City of Ryde Submission

MEEP - Schools Project Modification (SSD-9343-Mod-4)

Seeking to delete public domain works, footpaths, pedestrian crossing
and extension of construction work hours

Submission Date: 22 November 2021

Figure 1.27: Recommended Moderate Scenario Cycling Infrastructure

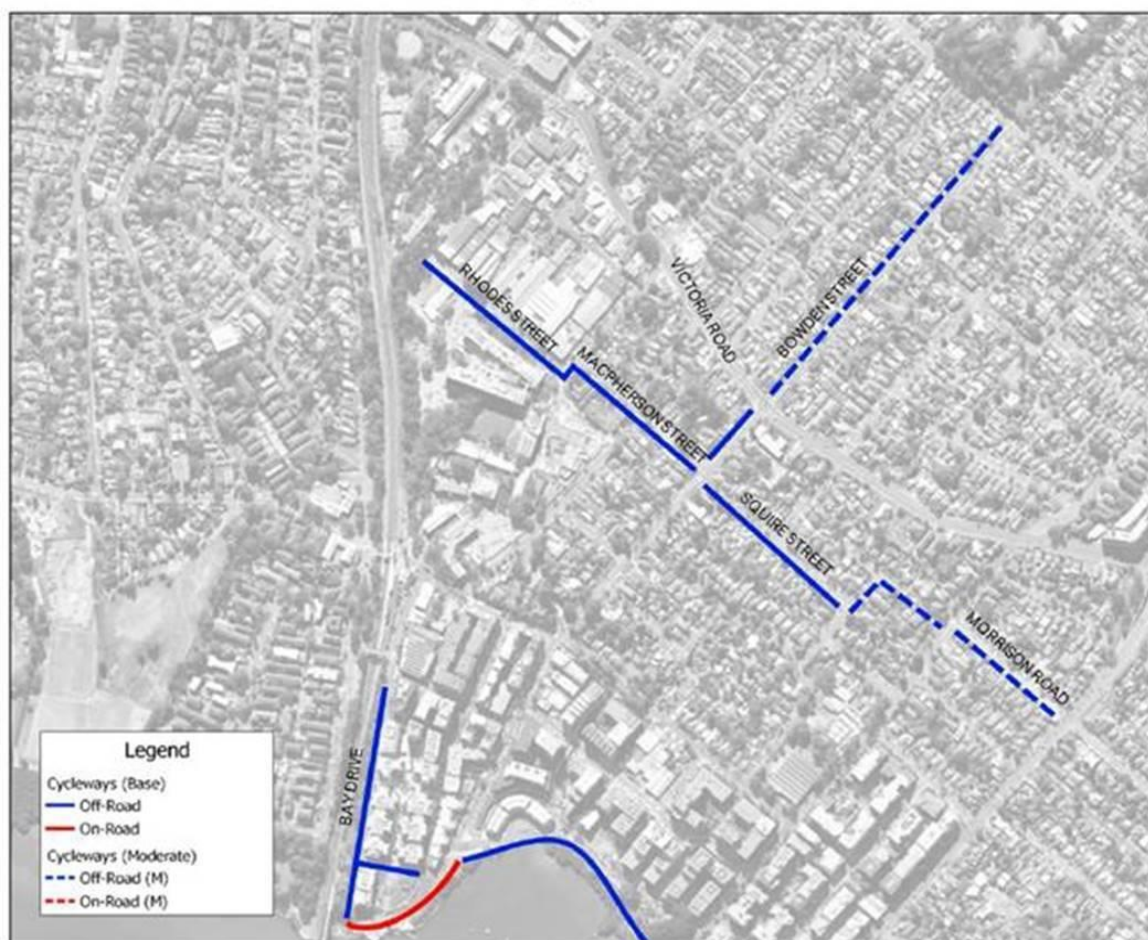
The proposed reduction in the width of the cycle path contradicts the recommendations provided within the latest Draft Transport Plan (School Travel Plan) prepared by GTA Consultants/ Stantec on behalf of the applicant dated 8 November 2021.

The Report was prepared to address Condition D17 of the consent, whereby section 1.7.2 of the Plan specifically recommends for an off-road cycle path within Squire Street. See extract below of Figure 1.27 of the Plan for reference.

A concession for a reduction to the width of the off-road path (from 2.5m to 1.35m) along the southern side of Squire Street can be considered provided other works such as the provision of a 1.2m wide footpath along the western side of Hermitage Road in addition to the 2.5m wide shared user path (as previously recommended by Council staff and shown within the approved Construction Certificate civil plans) can be delivered by the applicant, which would be considered an appropriate trade-off. A 1.2m wide footpath on the western side of Hermitage Road would provide safe access for pedestrians being dropped off/picked up on this side of the road.

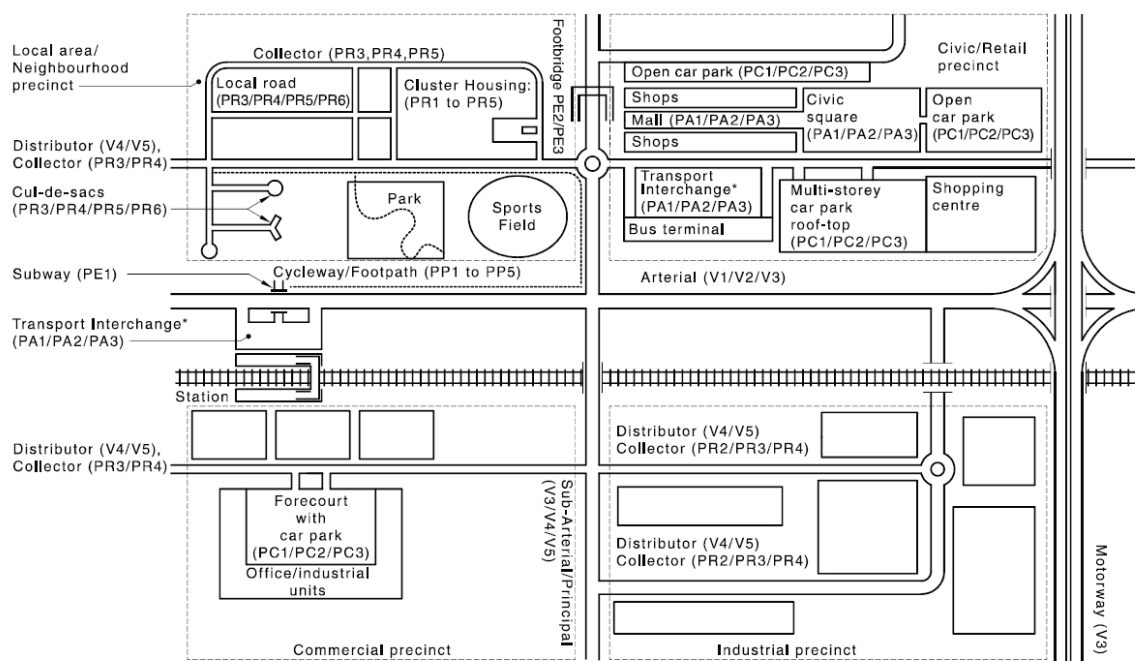
7. Proposed to delete Condition D12 in relation to the need for the provision of a wombat pedestrian crossing at the northern end of Mellor Street near/at its intersection with Victoria Road.

Council Officers do not support the removal of this condition as it relies on the outcome of consultation under Condition D10. Council would be open to alternative works as an appropriate trade-off to this requirement in accordance with the condition if consent.
